Product Change Notification (PCN)

PCN Number	510049	Date Issued	May 14, 2021
Reason for Change	Change to Product		
Change Type Description	This letter is to inform you that changes are being made to the part(s) identified in this Notice. The change may affect the fit, form, function or appearance of the parts, or it may result in a change to the specification. The pictures below show an example of the possible differences.		
Reason for Short Notice	Corrective Actions		
Assessment of Change	Test report/Specification Test Report		
Internal Molex Qualification Date	May 28, 2021		
Sample Availability Date (Changed Part)	May 28, 2021		
Planned Implementation Date	July 01, 2021		
Method of Identifying Change	Lot information on label

Overview

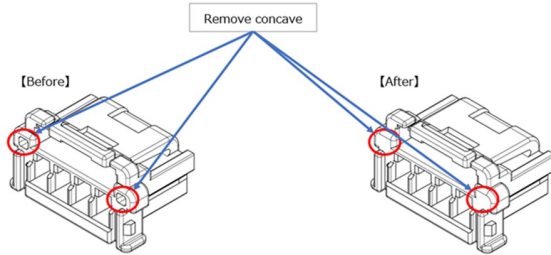
- **Change Point:**
 - Remove the concave and then return to the original size of the air venting
- **Reason:**
 - To reduce quality risks of Bubble & Gate flash
- **Product Impact**
 - Impact to cosmetic appearance. But there is no change of Fit or Function.
- **Part Number Impact**
 - 505151-0301/505151-0401/505151-0501/505151-0601/505151-0701/505151-0801/505151-0901
 - 505151-1001/505151-1101/505151-1201/505151-1301/505151-1401/505151-1501/505151-0300
 - 505151-0400/505151-0500/505151-0600/505151-0700/505151-0800/505151-0900/505151-1000
 - 505151-1100/505151-1200/505151-1300/505151-1400/505151-1500
- Qualification Reports and samples available upon request after 1st of May,2021
